UN Regulation No. 16 (Safety-belts)

Proposal for Supplement 5 to 08 Series of Amendments to UN Regulation No. 16 (Safety-belts) *

Submitted by the expert from Spain

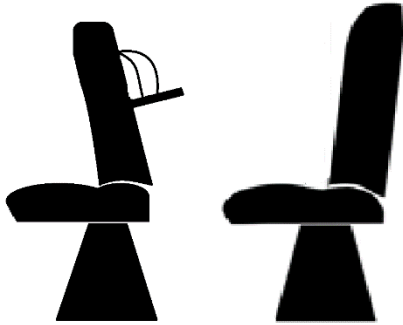
Note b: For M₂ and M₃ vehicles of all classes, forward facing Seats facing Built in Child Restraint Systems shall be equipped with at least Ar seat belts. "
